**SERVICE BULLETIN**

**N° 139-559**

**ATA 71 - FIREWALLS RETROMOD**

This Service Bulletin is issued in order to provide the necessary instruction to reinforce the firewalls by performing the installation of the firewalls retro modifications P/N 3G7130P01411 and P/N 3G7130P01412.

**Figure 1**

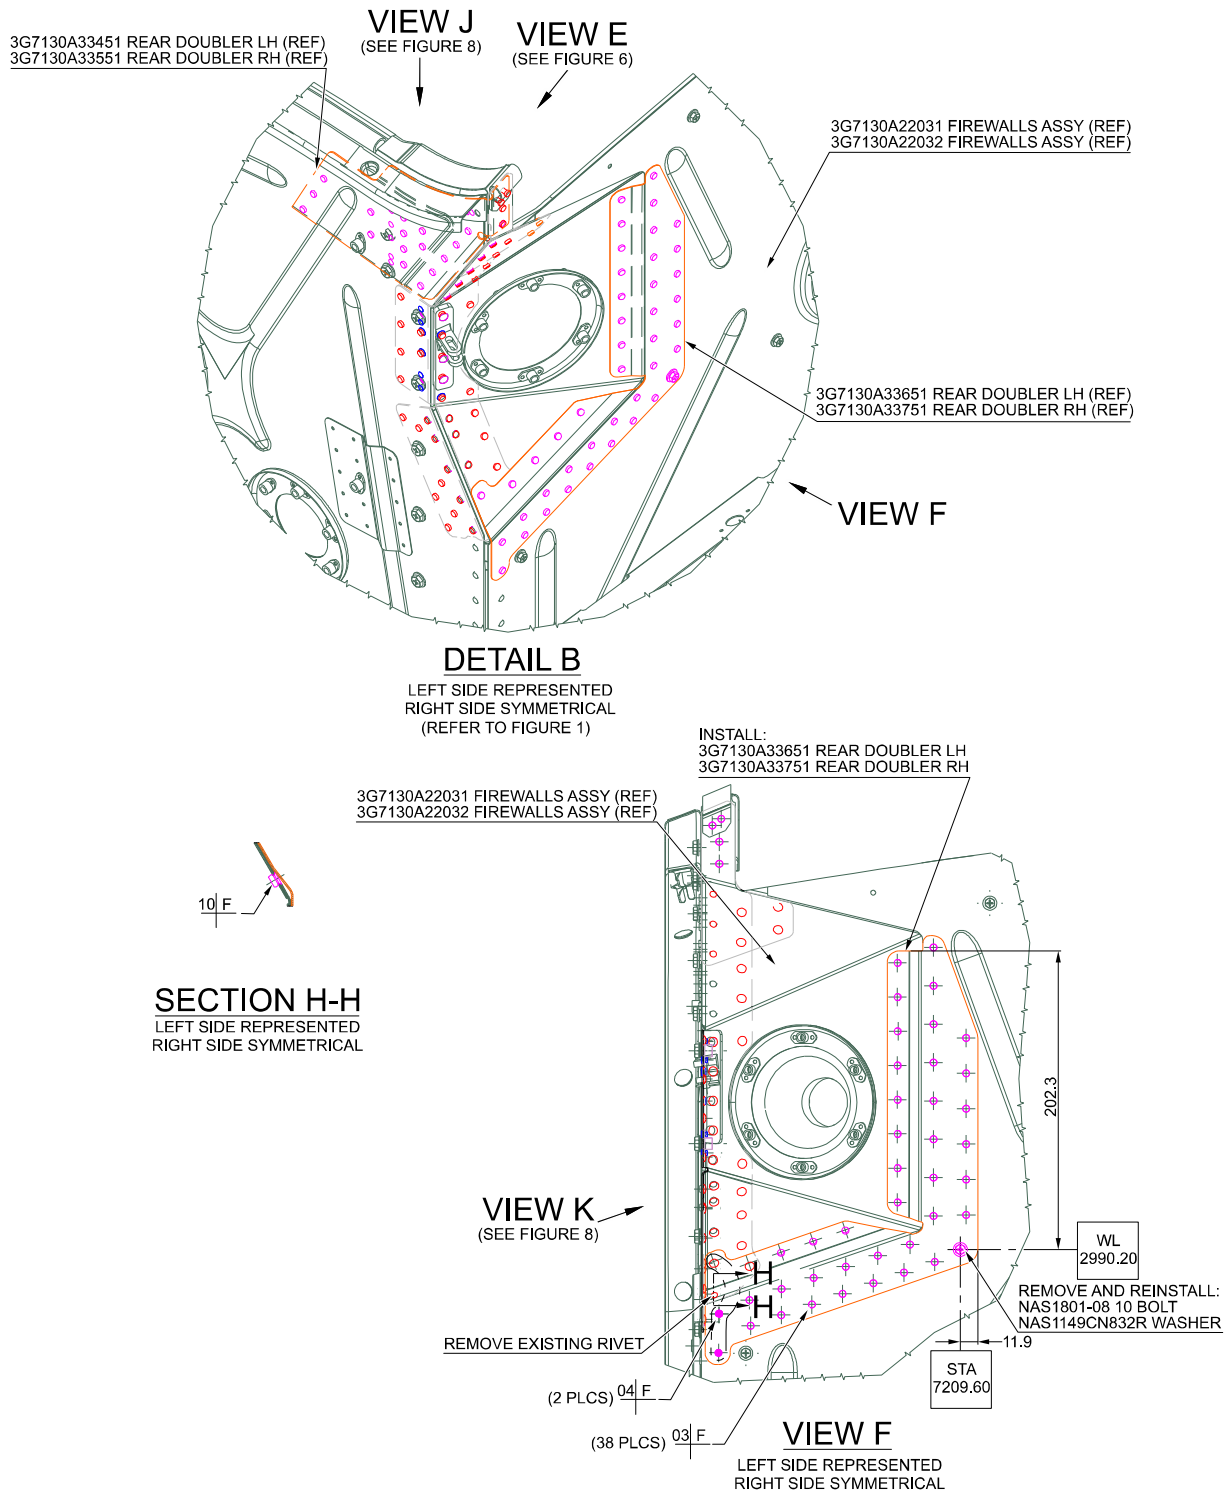
2. In accordance with DM 39-A-06-40-00-00A-028A-A and with reference to Figure 1, gain access to the area affected by the installation and perform the firewalls retromod P/N 3G7130P01411 as described in the following procedure:
  - 2.1 With reference to Figure 3 view C, remove and retain for later reuse the pin assy alignment eccentric P/N AAP141CH160-2, the n°4 anchor nuts P/N MS21069-3K and the clamp P/N 7C31-1AA.

**Figure 4**

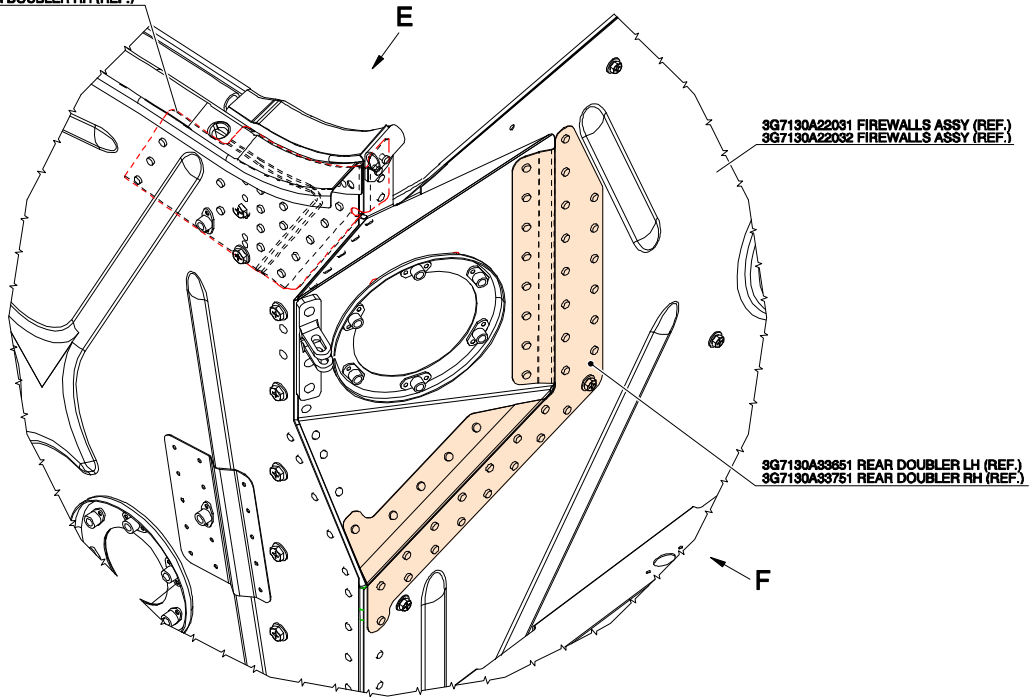
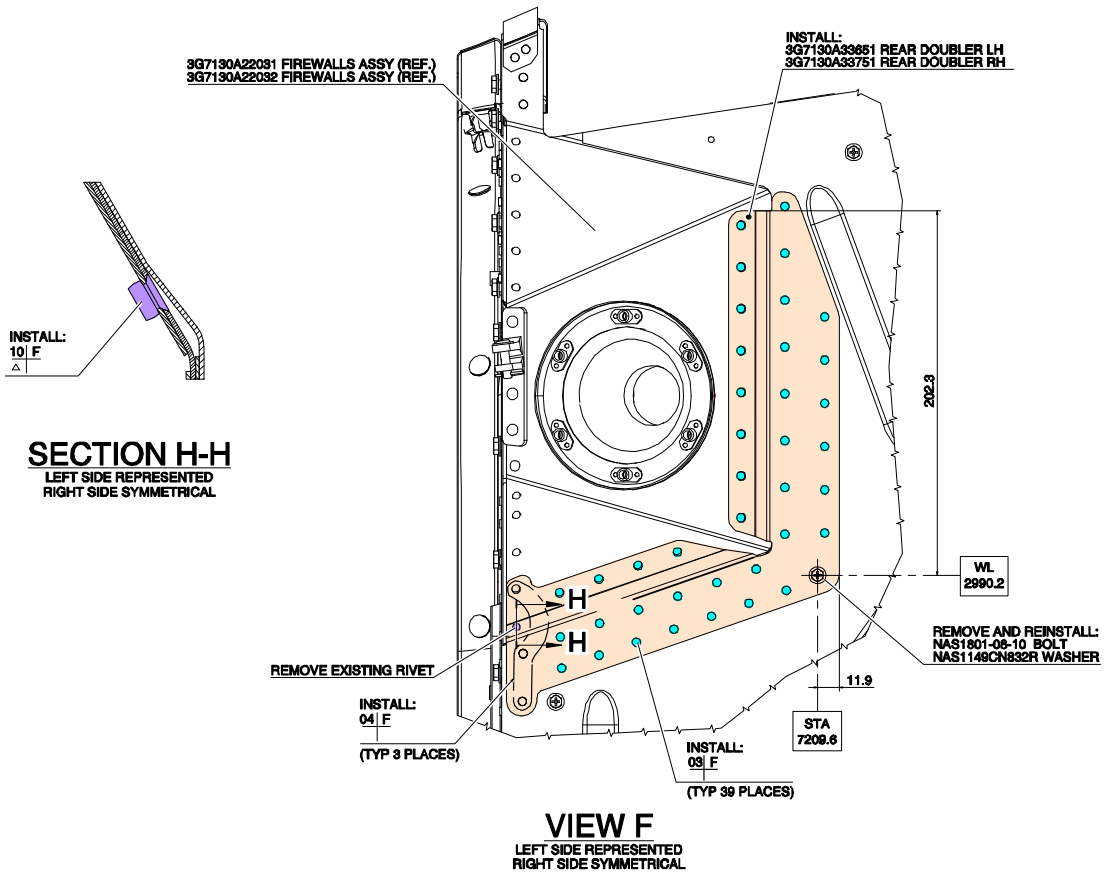
- 2.8 With reference to Figure 4 view F, remove and retain for later reuse the bolt P/N NAS1801-08-10 and washer P/N NAS1149CN832R. Remove and discard the indicated existing rivet.

- 2.9 With reference to Figure 4 detail B and view F, install the rear doubler LH P/N 3G7130A33651 by means of n°38 rivets P/N MS20615-4M3R and n°2 rivets P/N MS20615-4M4.

- 2.10 With reference to Figure 4 view F, install the previously removed bolt P/N NAS1801-08-10 and washer P/N NAS1149CN832R.
- 2.11 With reference to Figure 6 view E, remove and discard the corner LH P/N 3P7119A23552 and the existing rivets. Retain for later reuse the n°4 anchor nuts P/N MS21071L3K and the n°2 anchor nuts P/N MS21069L3K.

**Figure 5**

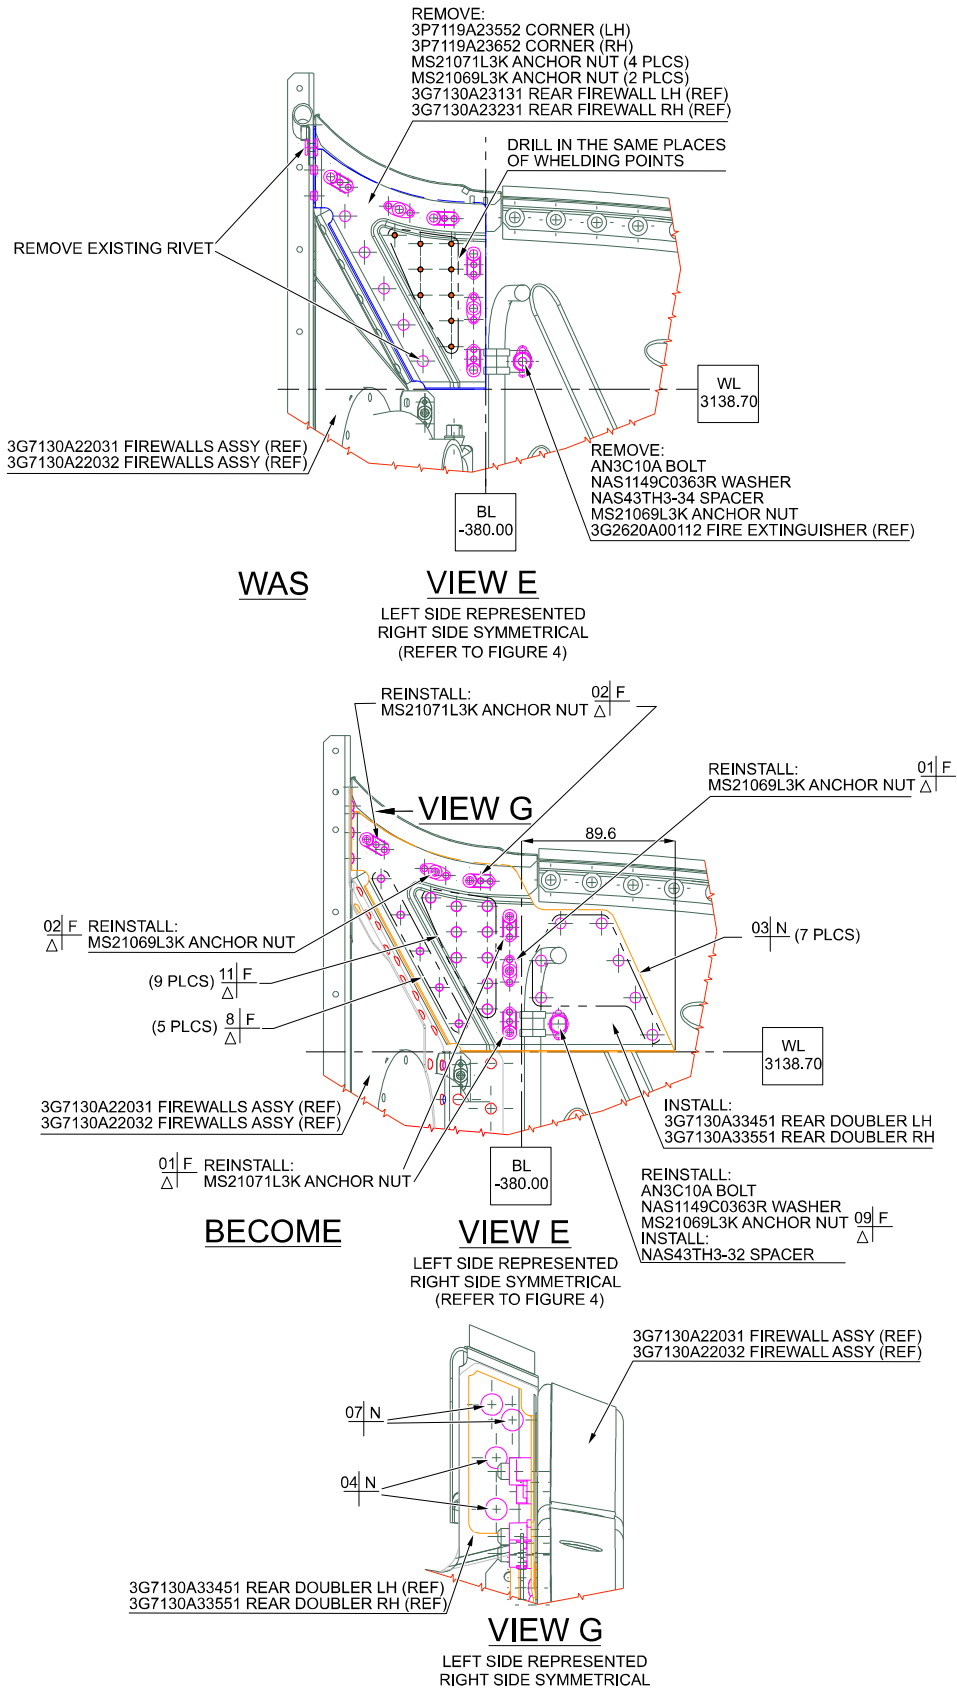
- 2.10 With reference to Figure 5 view F, remove and retain for later reuse the bolt P/N NAS1801-08-10 and the washer P/N NAS1149CN832R. Remove and discard the indicated existing rivet.

- 2.11 With reference to Figure 5 view F and detail B, install the rear doubler LH P/N 3G7130A33651 by means of n°39 rivets P/N MS20615-4M3R and n°3 rivets P/N MS20615-4M4.

- 2.12 With reference to Figure 5 view F, install the previously removed bolt P/N NAS1801-08-10 and washer P/N NAS1149CN832R.
- 2.13 With reference to Figure 5 view F and section H-H, install the rivet P/N NAS1200-4-3.

**Figure 6**

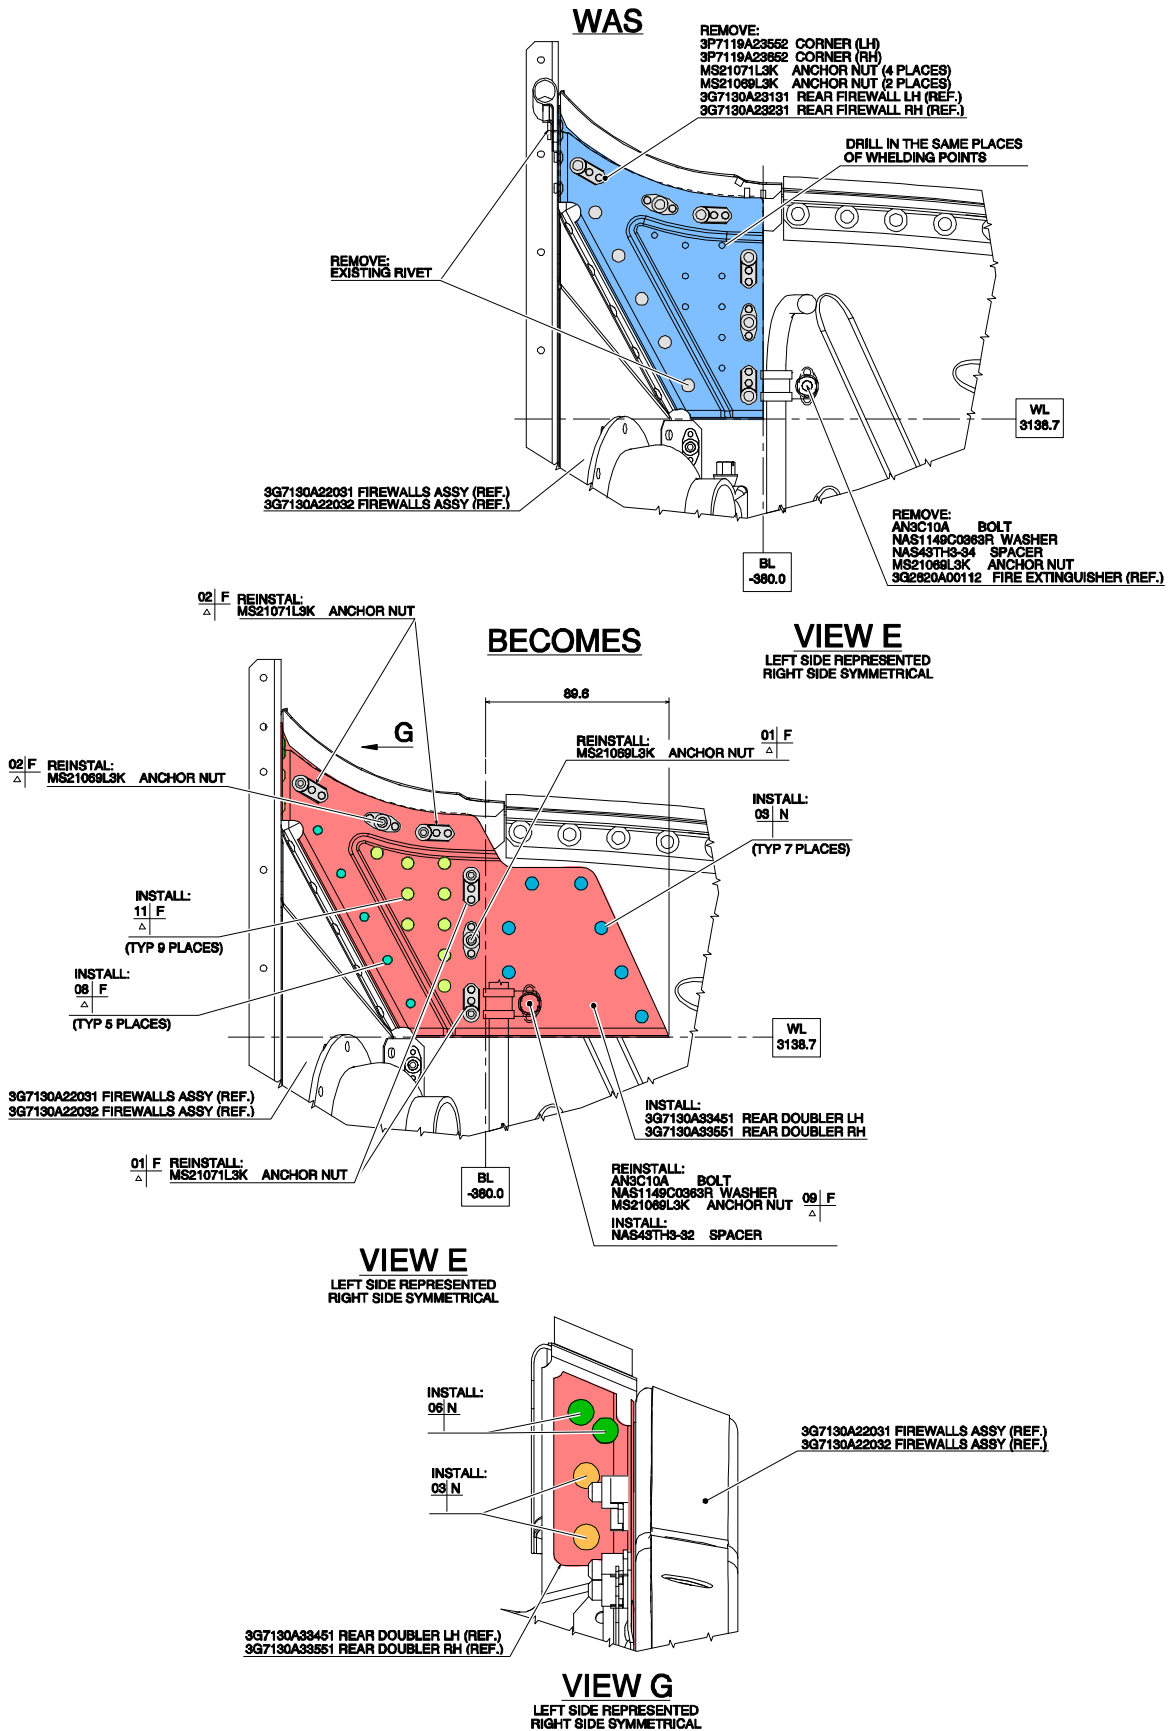
- 2.12 With reference to Figure 6 view E, drill rivet holes  $\varnothing$  0.2 in correspondence of weld joints position.
- 2.13 With reference to Figure 6 view E, remove and retain for later reuse the bolt P/N AN3C10A, the washer P/N NAS1149C0363R, and the anchor nut P/N MS21069L3K. Remove and discard the spacer P/N NAS43TH3-34.

- 2.17 With reference to Figure 6 view E, install the rear doubler LH P/N 3G7130A33451 and re-install the left upper connector P/N 3P7119A31752 by means of n°7 rivets P/N MS20615-4M3R, n°9 rivets P/N NAS1200-5-5 and n°5 rivets P/N NAS1200-4-4-5.

- 2.18 With reference to Figure 6 view E, reinstall the n°4 anchor nuts P/N MS21071L3K and the n°2 anchor nuts P/N MS21069L3K by means of n°6 rivets P/N MS20427M3-4 and n°6 rivets P/N MS20427M3-4-5.

- 2.19 With reference to Figure 6 view E, re-install the anchor nut P/N MS21069L3K by means of n°2 rivets P/N MS20427M3-3.
- 2.20 With reference to Figure 6 view E, install the spacer P/N NAS43TH3-32 by means of previously removed bolt P/N AN3C10A and washer P/N NAS1149C0363R.
